Canton Town Hall Reno
Project No.: 2023-001-02
Issue to: Bidders

Town of Canton, Owner
Contract Document Date: July 07, 2025
Addendum Date: March 31, 2026

END OF ADDENDUM 1

B1 ENLARGED WOMEN 107
1/4" = 1'-0"

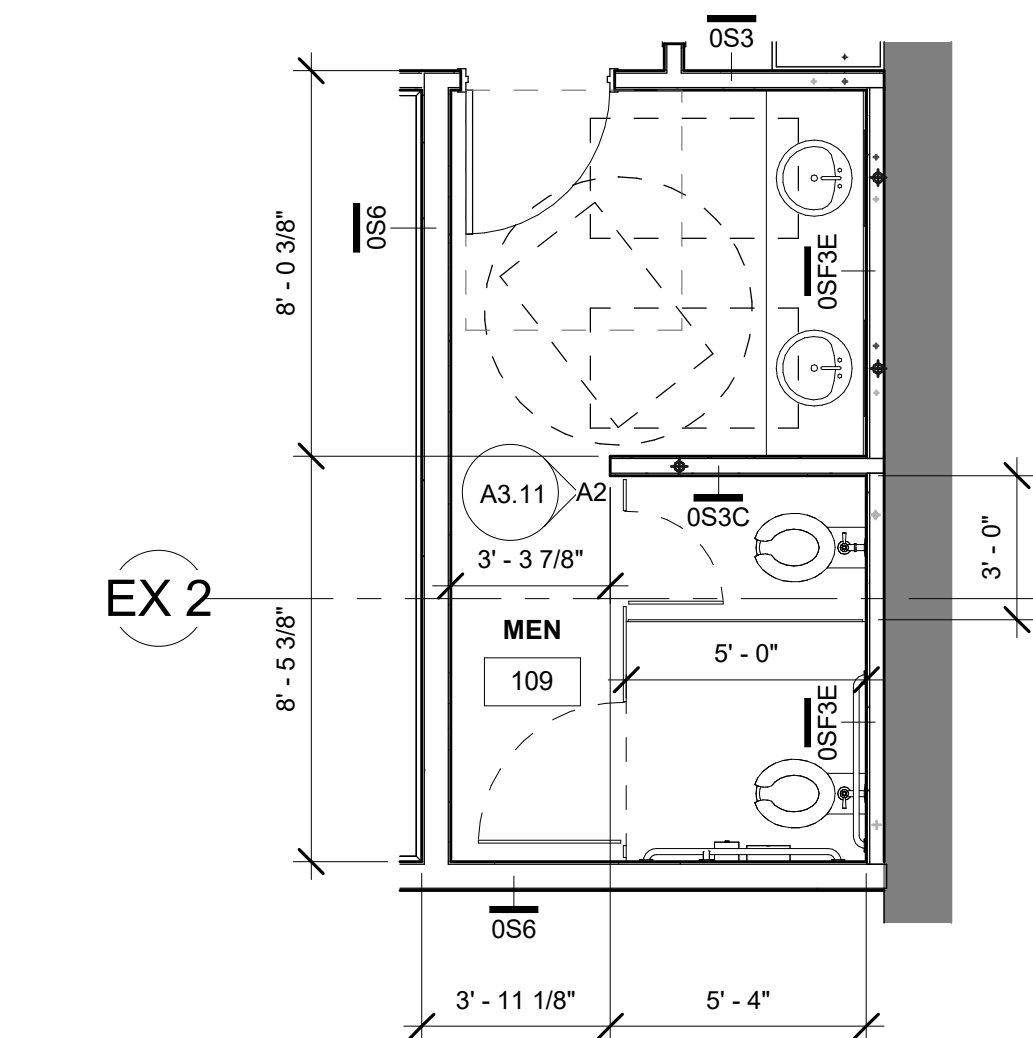
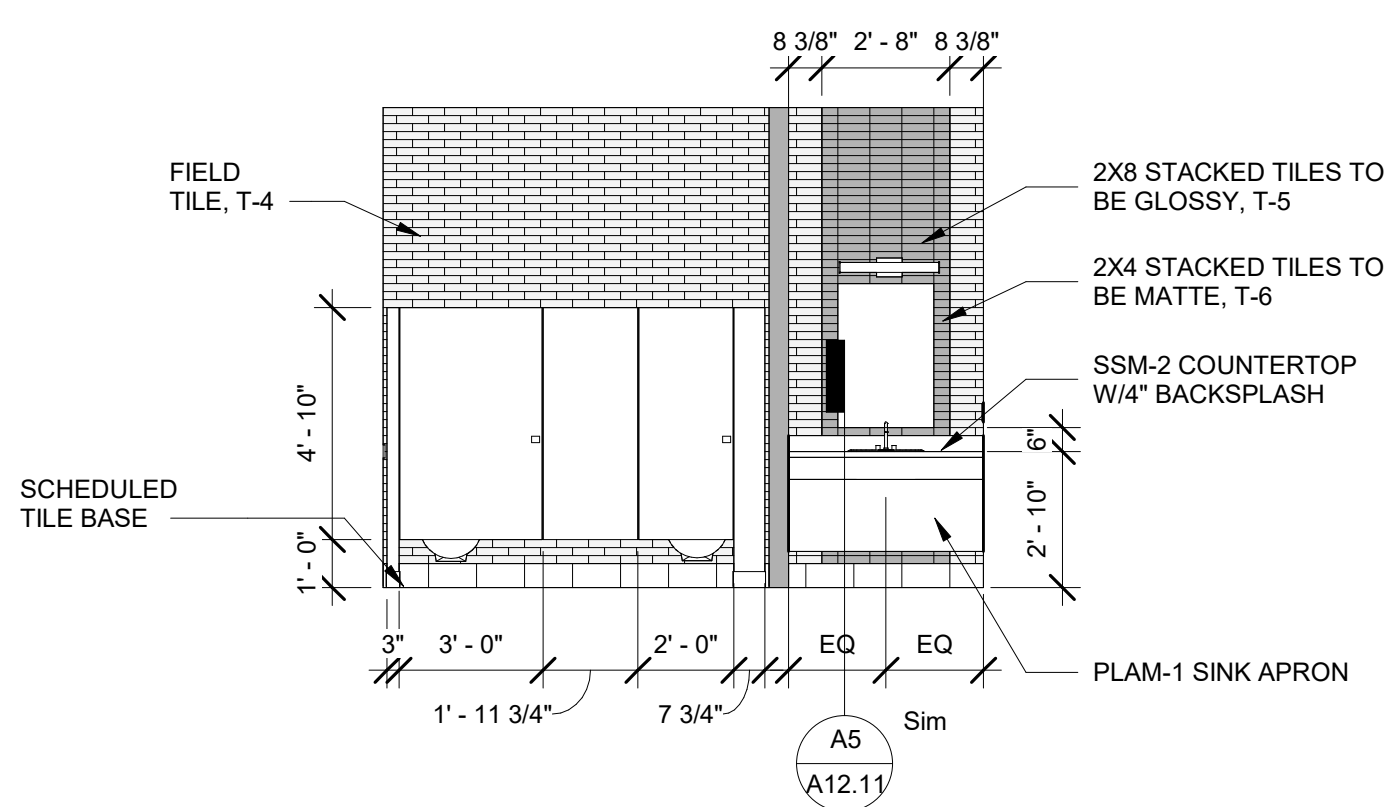
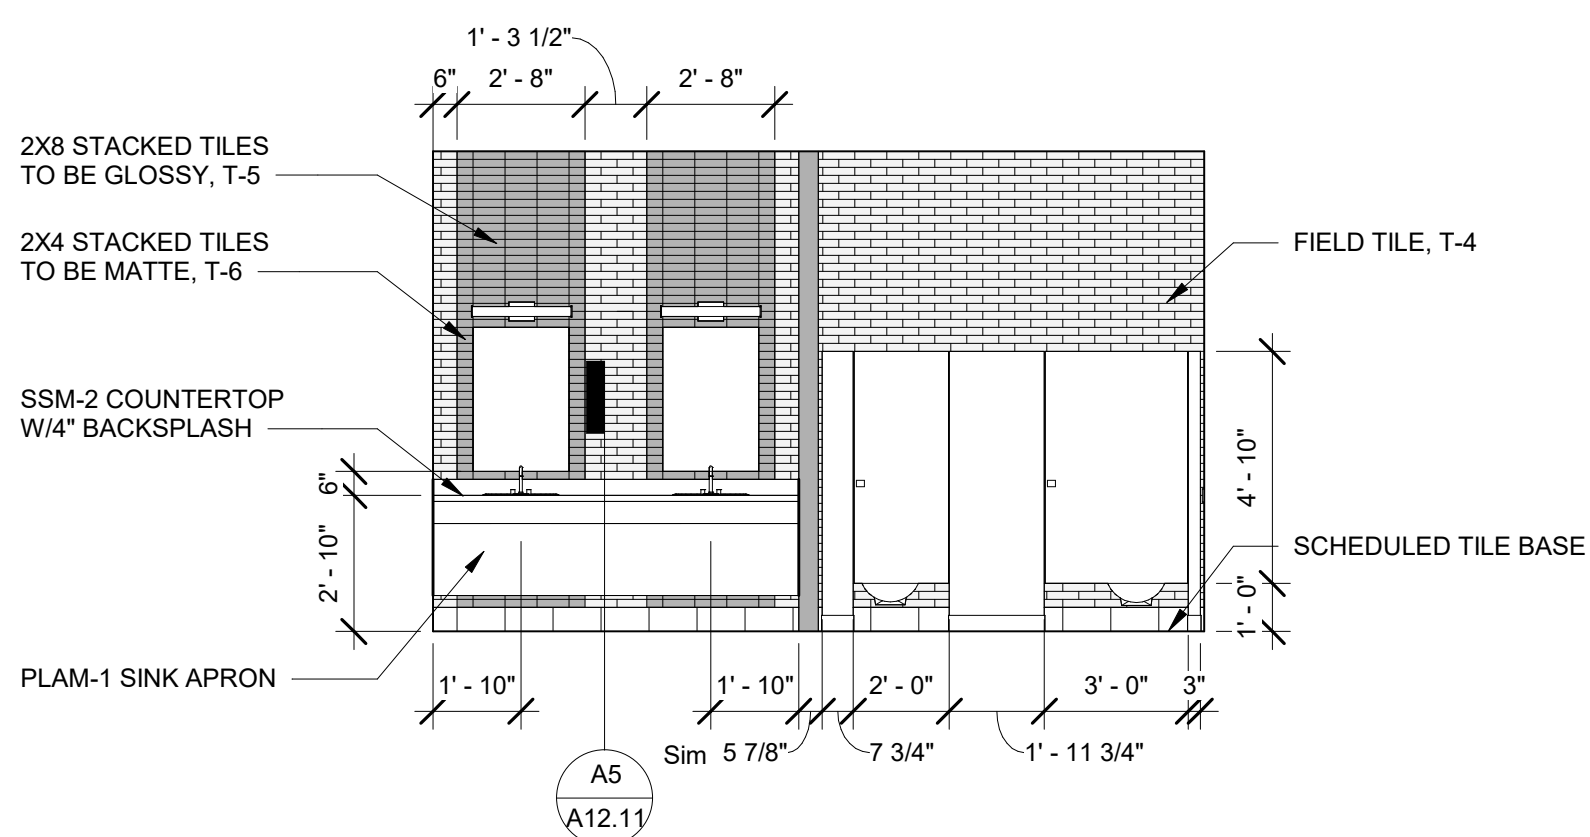
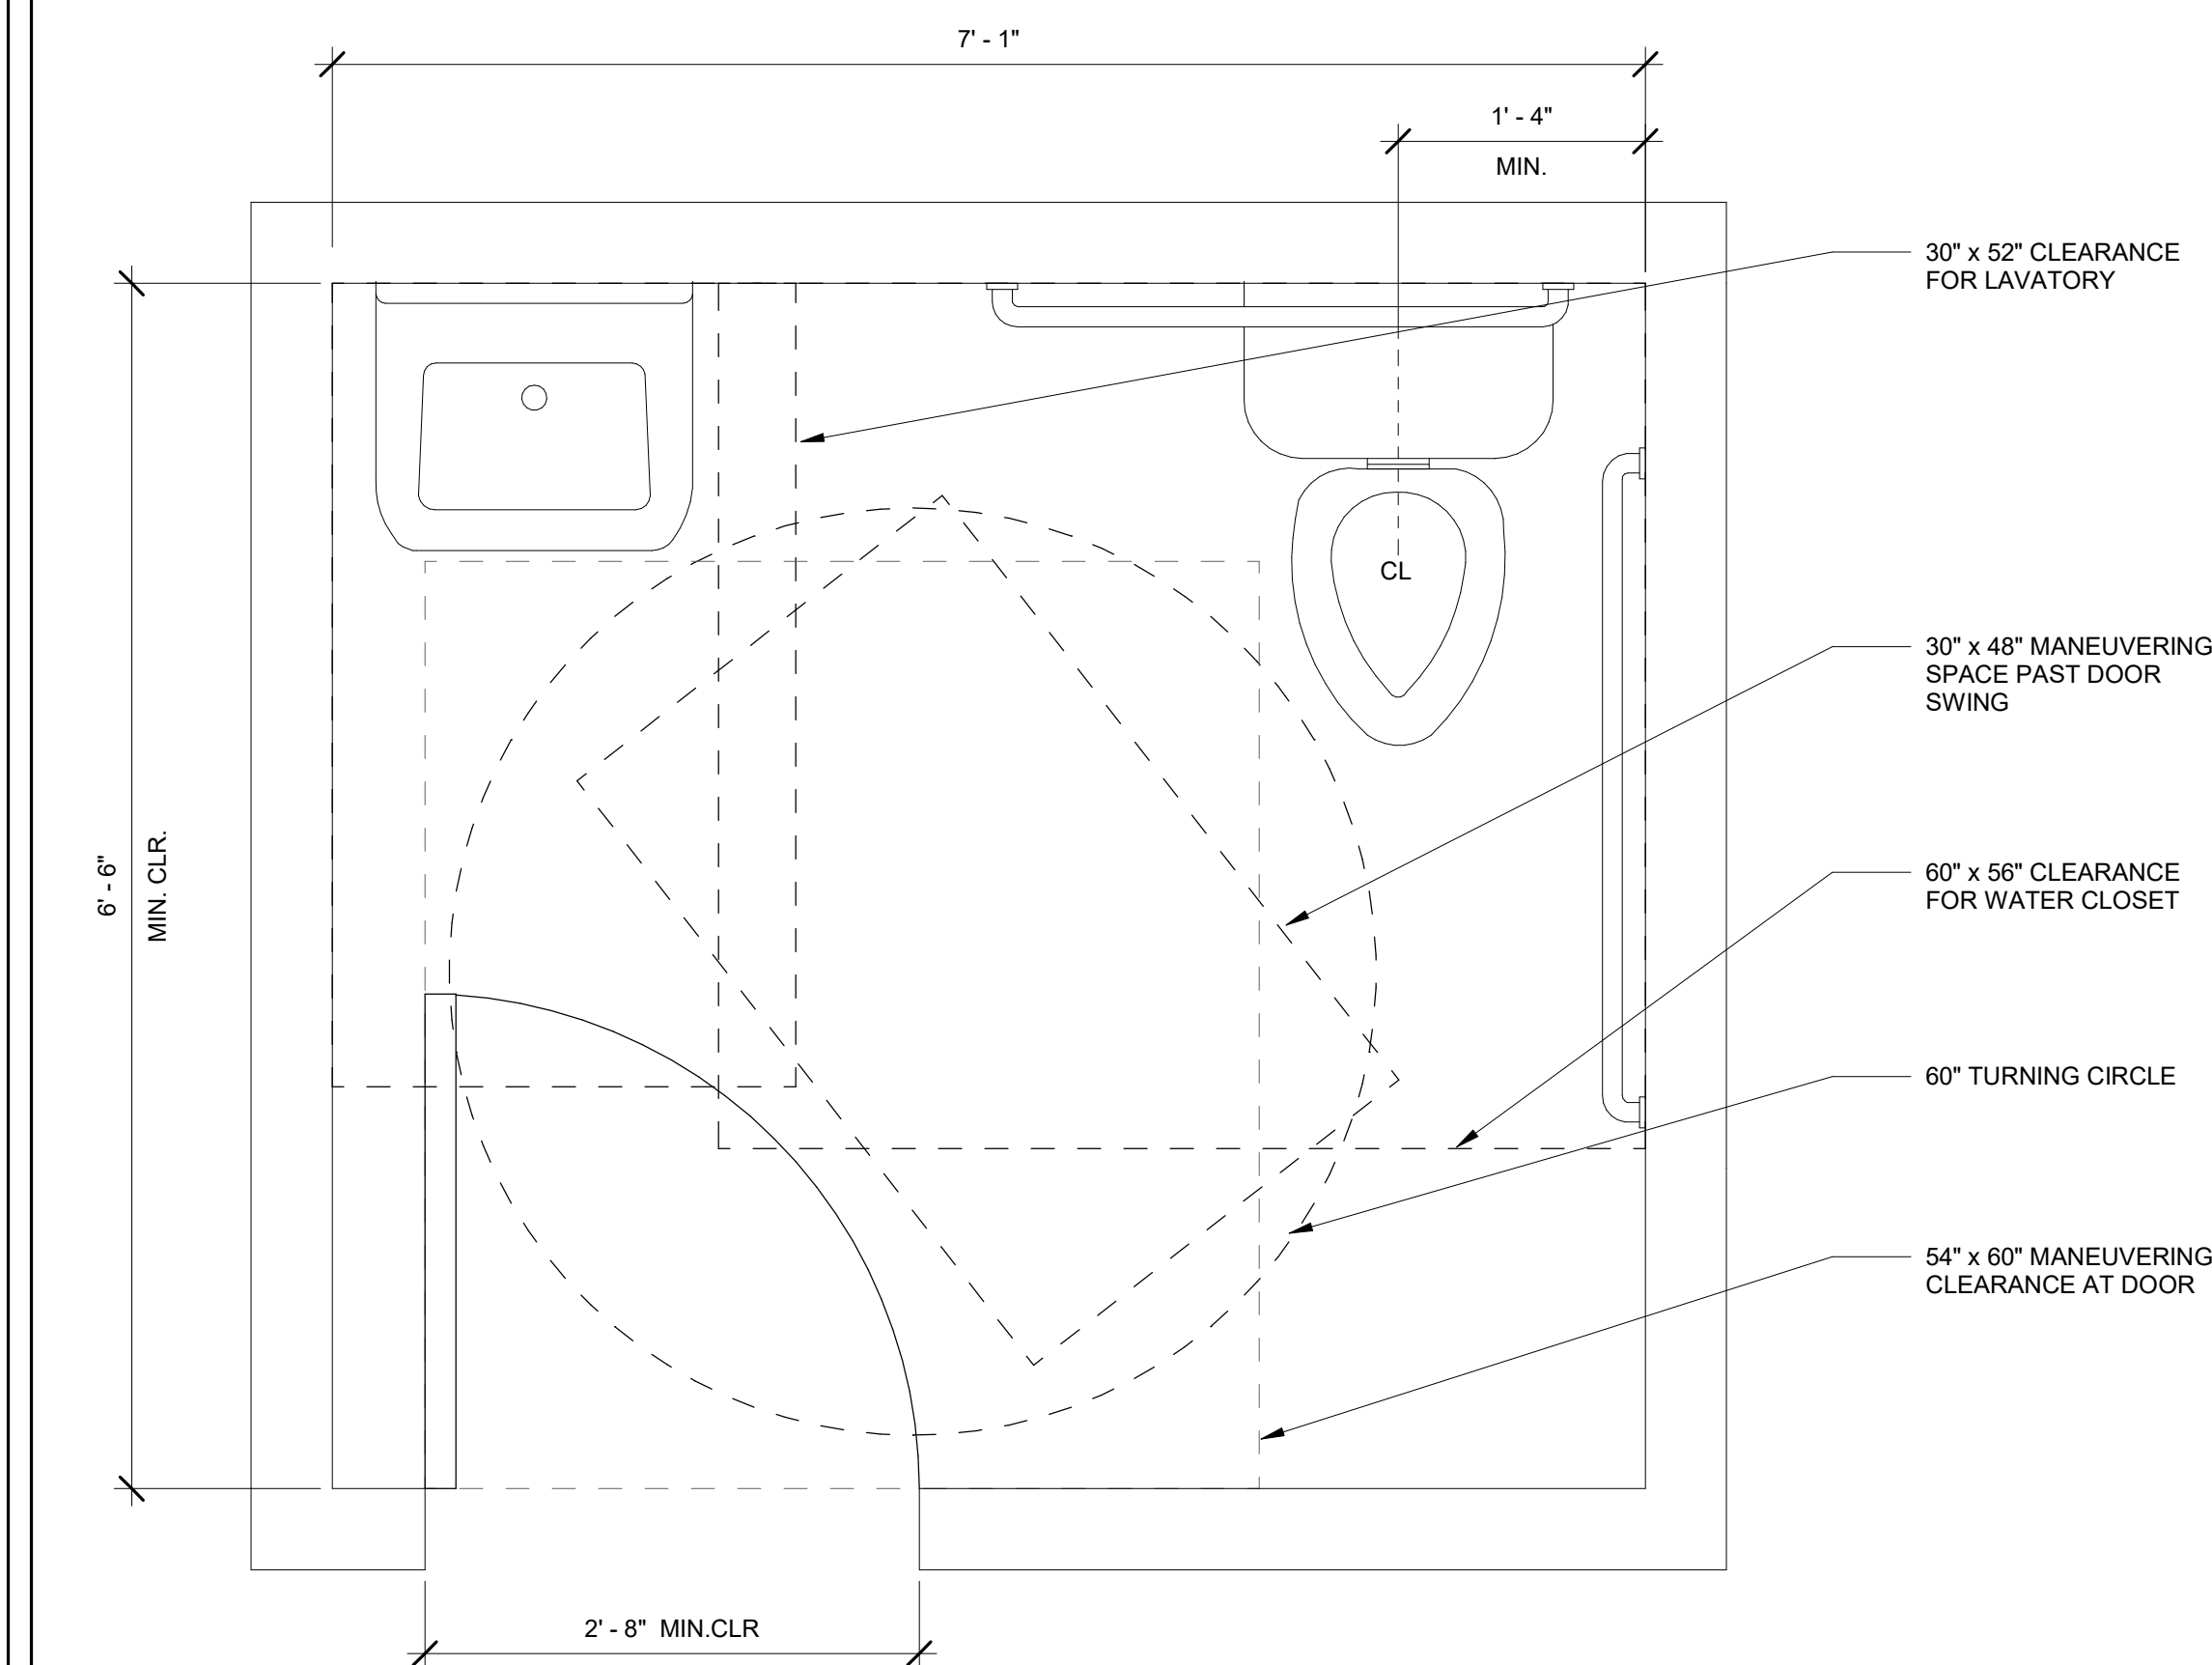
- c) Please confirm base in rooms 107 and 109. Schluter Dilex is the base for this room, however, this product is not a Please clarify the base in rooms 107 and 109. The TS-1 Schluter Dilex is the only "Base" called out for this room. However, this material is only applicable in wall tile/Floor tile transitions.

- 1) See revised Drawings.
- d) Please confirm electrical fixtures M, N, and P are not used. They are on the fixture schedule but not used in the drawings.
